HISTORIC AND DESIGN REVIEW COMMISSION

HDRC CASE NO: 2024-305
ADDRESS: 1510 E HOUSTON ST
LEGAL DESCRIPTION: NCB 576 BLK 15A LOT E 31.1 FT OF 2
ZONING: RM-4, H
CITY COUNCIL DIST.: 2
DISTRICT: Dignowity Hill Historic District
APPLICANT: Felipe Navarro/ALCALA FELIPE DE JESUS NAVARRO
OWNER: Felipe Navarro/ALCALA FELIPE DE JESUS NAVARRO
TYPE OF WORK: Construction of a 1-story, single-family residential structure
APPLICATION RECEIVED: August 18, 2024
60-DAY REVIEW: October 17, 2024
CASE MANAGER: Edward Hall

REQUEST:

The applicant is requesting a Certificate of Appropriateness for approval to construct a 1-story, single-family residential structure on the vacant lot at 1510 E Houston Street. This lot is located within the Dignowity Hill Historic District.

SITE PLAN
 SCALE: 3/16"=1'-0"

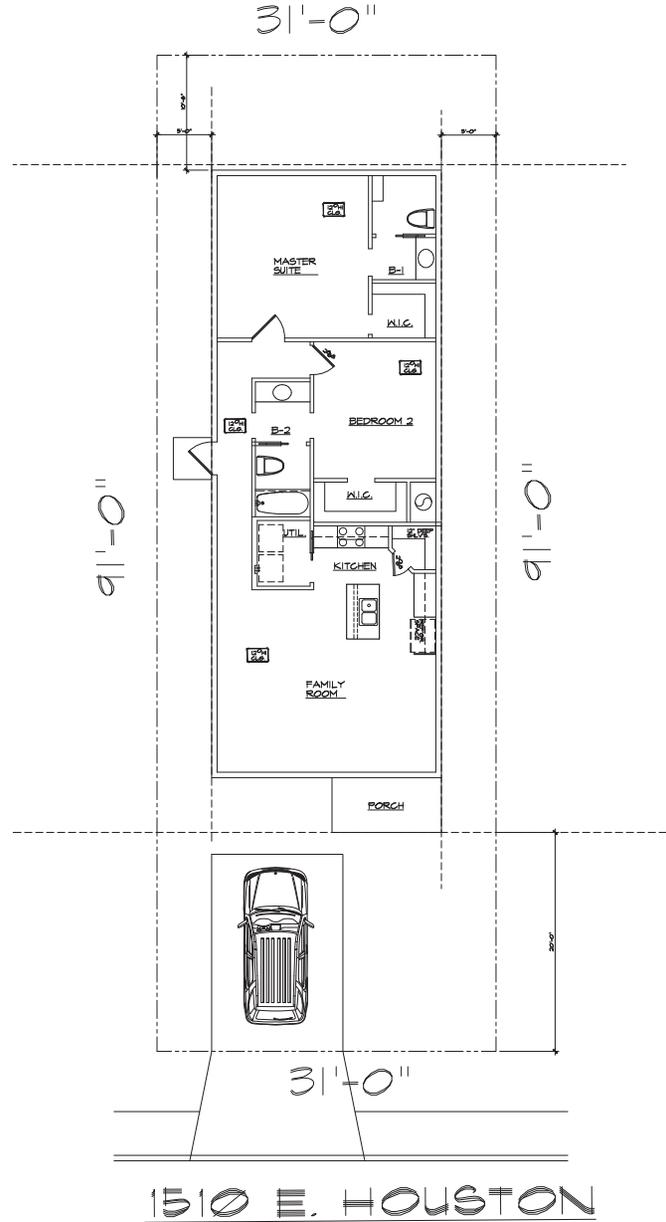
- b. **CONTEXT & DEVELOPMENT PATTERN** – The applicant is proposing new construct at 1510 E Houston Street, a lot currently void of structures. This block of E Houston currently features three (3) structures that front E Houston. Two of the structures feature one story in height. Per the submitted site plan, this lot features an overall width of 31' – 0" and an overall depth of 91' – 0".

- c. **SETBACKS & ORIENTATION** – According to the Guidelines for New Construction, the front facades of new buildings are to align with front facades of adjacent buildings where a consistent setback has been established along the street frontage. Additionally, the orientation of new construction should be consistent with the historic examples found on the block. The applicant has proposed a setback of 20' – 0" from the front property line to the front porch. The applicant has not provided a setback diagram showing the proposed setback's relationship with the adjacent structures. Staff finds that the proposed new construction should feature a setback that is equal

to or greater than that of the setback at 1506 E Houston, the historic structure to the immediate west of the proposed new construction.

- i. LOT COVERAGE – The applicant has not provided a building to lot ratio. Per BCAD records, this lot features 2,944 square feet in size. Per the submitted site and floor plan, the applicant has proposed a footprint of 1,270.5 square feet. The Guidelines for New Construction 2.D.i. notes that new construction should be consistent with adjacent historic building s in terms of the building to lot ratio. Footprints of new construction should be limited to no more than fifty (50) percent of the total lot area, unless adjacent historic buildings establish a precedent with a greater building to lot ratio. The proposed footprint is consistent with the Guidelines.

- p. DRIVEWAY & FRONT YARD PARKING – The applicant has proposed to install both a curbcut and driveway to provide vehicular access from E Houston Street into the property. Given the narrow width of the lot, the proposed driveway will terminate into the front façade of the proposed new construction and will create a front yard parking condition. Staff does not find the installation of front yard parking to be in keeping with the Guidelines; however, given the lack of additional space on this lot, staff finds that the proposed driveway and parking location may be appropriate provided the applicant incorporates a pervious paving material that doubles as a landscaping element, such as decomposed granite, and that the driveway be relocated to the side property line. The driveway should not exceed ten (10) feet in width, per the Guidelines for Site Elements 5.B.i.

- i. That the proposed new construction feature a setback that is equal to or greater than that of the setback at 1506 E Houston, the historic structure to the immediate west of the proposed new construction. A detailed setback diagram should be provided and submitted to OHP staff that confirms the approved setback and documents its placement by both measurement and graphics.

- x. That the applicant incorporates a pervious paving material that doubles as a landscaping element, such as decomposed granite, for the proposed driveway, as noted in finding p. Additionally, staff recommends that the propose driveway be pushed to the property line and feature no more than ten (10) feet in width.
- xi. That a front walkway be installed that it feature a profile that is consistent with those found historically on the block; historically three (3) to four (4) feet in width and poured concrete, as noted in finding q.
- xii. That all mechanical equipment be screened from view from the right of way, as noted in finding r.

FRONT ELEVATION
SCALE: 1/4" = 1'-0"

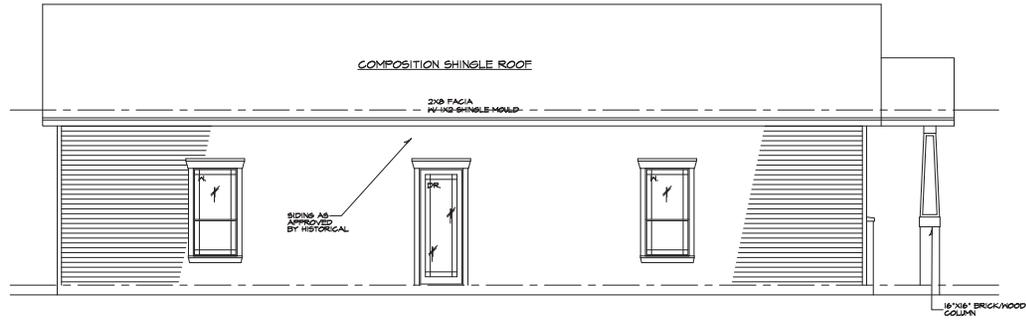
- g. PRIMARY ROOF FORM – The applicant has proposed for the new construction to feature a front facing gabled roof. Generally, staff finds the proposed roof form to be appropriate; however, staff finds that the proposed boxed soffits and gable returns should be eliminated, as this profile is not found historically within the historic district.

- h. PORCH ROOF FORM – The applicant has proposed for the porch roof to feature a gabled form that extends out from the primary gabled roof. Staff finds that the proposed porch roof form should be amended to closer relate to historic roof profiles that are found on historic shotgun structures within the district. Historically, structures of this width would have featured one, incorporated porch roof; either the primary gabled roof extended out to cover a full width porch, or a shed porch roof was constructed that covered a full width porch. Staff finds that either of these profiles would be appropriate.

- j. MATERIALS – The applicant has proposed materials that include lap siding, a composition shingle roof and brick wainscoting on the front façade. Staff finds the installation of horizontal lap siding to be appropriate. Staff finds that either wood siding or composite siding featuring an exposure of four (4) inches is appropriate. Additionally, staff finds that a composition shingle roof is appropriate. Staff does not find the proposed brick wainscoting to be appropriate as brick is not found historically within the district in this manner. Staff finds that one material should exist on each façade.

- m. PORCH DESIGN – As noted in finding h, staff finds that the proposed porch and porch roof form that have been proposed are atypical for those typically found on historic shotgun structures. Staff finds that the proposed porch roof form should be amended to closer relate to historic roof profiles that are found on historic shotgun structures within the district. Historically, structures of this width would have featured one, incorporated porch roof; either the primary gabled roof extended out to cover a full width porch, or a shed porch roof was constructed that covered a full width porch. Staff finds that either of these profiles would be appropriate and should be incorporated into the design. Additionally, staff finds that porch columns should feature columns that

- iii. That the proposed boxed soffits and gable returns be eliminated, as this profile is not found historically within the historic district.
- iv. That the proposed porch roof form be amended to closer relate to historic roof profiles that are found on historic shotgun structures within the district. Historically, structures of this width would have featured one, incorporated porch roof; either the primary gabled roof extended out to cover a full width porch, or a shed porch roof was constructed that covered a full width porch. Staff recommends either of these forms be incorporated into the design.

- vi. That the proposed brick wainscoting be eliminated and that one, uniform façade material be installed throughout.
- vii. That wood or aluminum clad wood windows be installed, as noted in finding k and that windows adhere to the adopted window standards. Windows should feature one over one profiles with equally sized sashes and no transom windows. Additionally, staff recommends that the proposed transom window above the front entrance roof be modified to relate to historically sized and proportioned transom windows.

- ix. That columns that are six (6) inches square with capital and base trim be installed. If tapered, Craftsman style columns are proposed, a dimensioned column detail should be submitted for review and approval.

LEFT SIDE ELEVATION
SCALE: 1/4" = 1'-0"

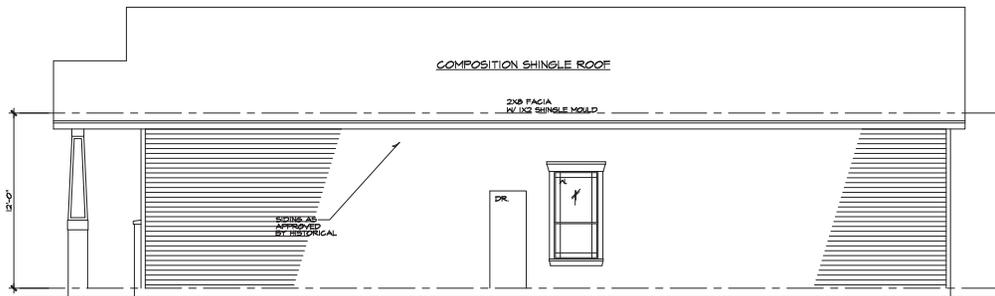
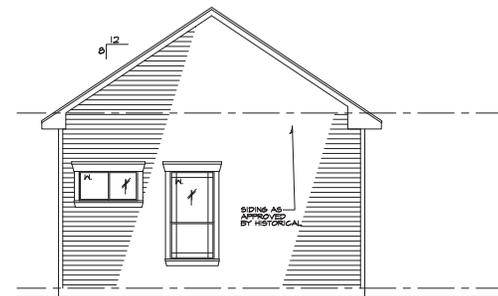
- l. FENESTRATION PROFILE – The applicant has proposed window openings on each façade; however, staff finds that additional window openings should be added to the east and west facades. Staff finds that added window openings should relate to those found historically within the district. Additionally, staff finds that windows should feature one over one profiles. Sliding window profiles should be modified. Transom windows should only occur over doors and should feature a single-lite profile with no faux divisions.

- viii. That additional fenestration be added to both the east and west facades and that the proposed sliding window on the rear façade be modified to feature a one over one profile.
